July 2016
FL702A-H
NHTSA #16V-121
REVISED NOTICE

Subject: FCCC XCP Chassis Power Steering Hoses

Models Affected: Specific Freightliner Custom Chassis XCP chassis manufactured April 26, 2013, through January 17, 2015.

Fig. 1, Steering Pump, Cummins ISX12

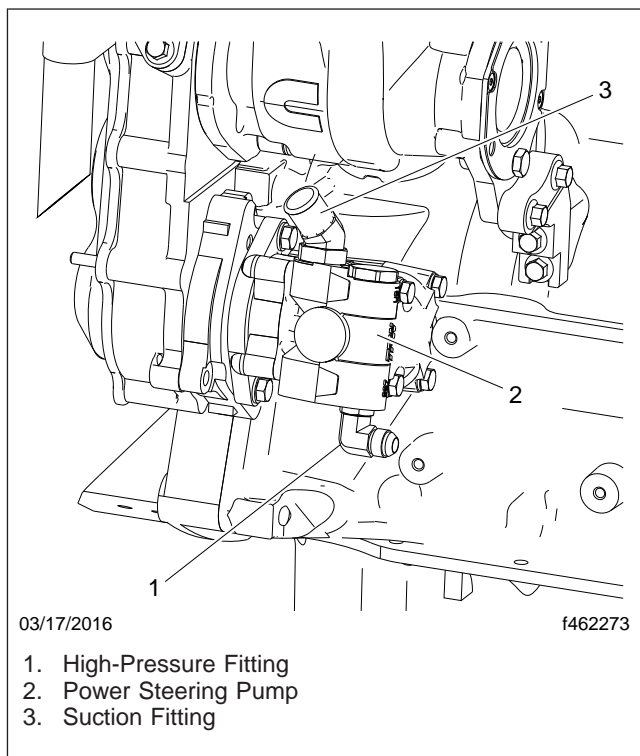
20. Remove the fittings from the power steering pump. Keep the supply (suction) fitting for the new power steering pump. Discard the high-pressure fitting and the power steering pump.
21. Remove and discard the power steering pump gasket from the mounting flange on the engine.
22. Install a new gasket on the mounting flange.
23. Install the fittings on the new power steering pump. Use the supply (suction) fitting removed earlier and tighten it 67 to 74 lbf-ft (91 to 100 N-m). Use a new high-pressure fitting and tighten it 33 to 36 lbf-ft (45 to 49 N-m).
24. Using the mounting bolts, install the power steering pump. Tighten the mounting bolts 25 lbf-ft (34 N-m). See [Fig. 1](#) and [Fig. 2](#).
